Environmental
Protection
Authority

Gorgon Gas Development and Jansz Feed Gas Pipeline – Inquiry
under Section 46 of the *Environmental Protection Act 1986*
to amend the implementation conditions of Ministerial
statements 769, 800, 965, and 1002 relating
to the emission of greenhouse gases

Chevron Australia Pty Ltd

Report 1729
September 2022

Figure 1: EPA's recommended GHG emissions reduction trajectory

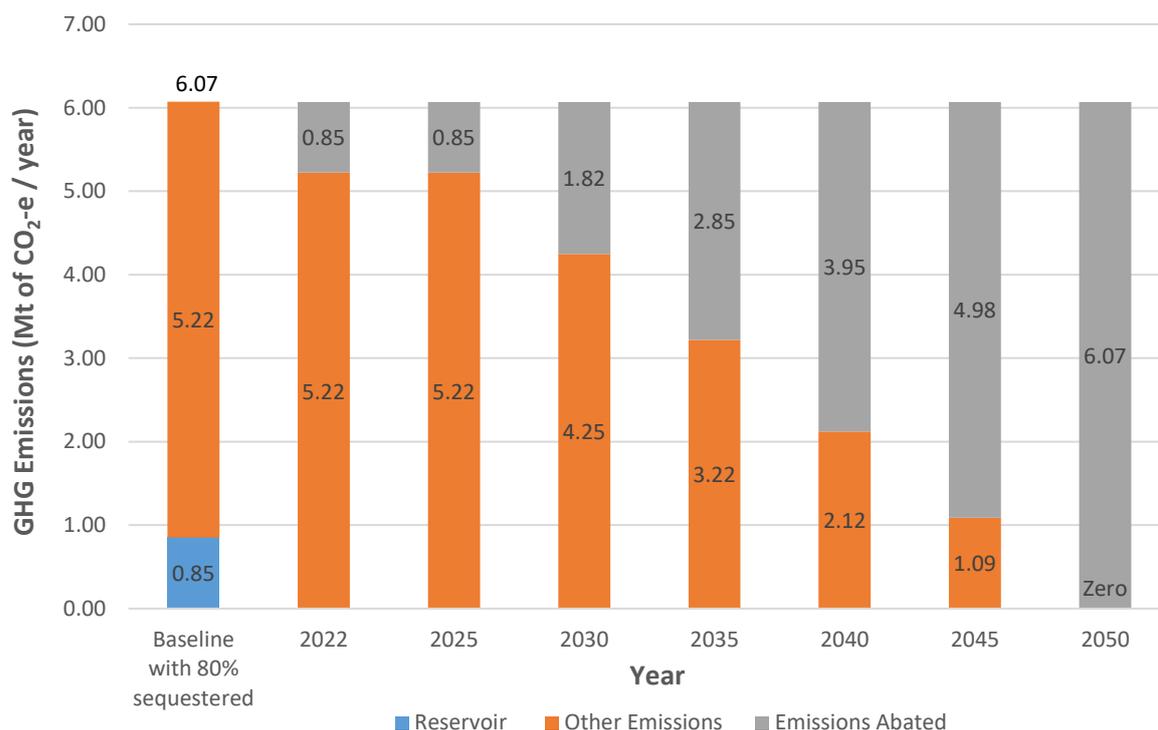
- Chevron's proposed trajectory relies heavily on the injection of reservoir CO₂.
- It is generally consistent with Chevron having already been required to implement best practice and ongoing review and adopt advances in technology and operations for the processing plant as per existing condition 27.2.

- Offsets are permitted if Chevron does not meet the trajectory.

The EPA's recommended trajectory is shown in Figure 1 below.

- A recommended baseline quantity of 6.073 Mtpa of CO₂-e / year which excludes the injection of 80% of reservoir CO₂ (i.e. 3.4 Mt of CO₂-e / year) given that Chevron should already be injecting at this rate (See Figure 1 above).

The EPA recommends that a baseline GHG emissions quantity of 6.073 Mt of CO₂-e / year (which excludes the injection of 80% of reservoir CO₂ (i.e. 3.4 Mt of CO₂-e / year) is appropriate in this case as it takes into account that Chevron should have already been injecting at least 80% of reservoir CO₂ at this point in time (see Figure 1).
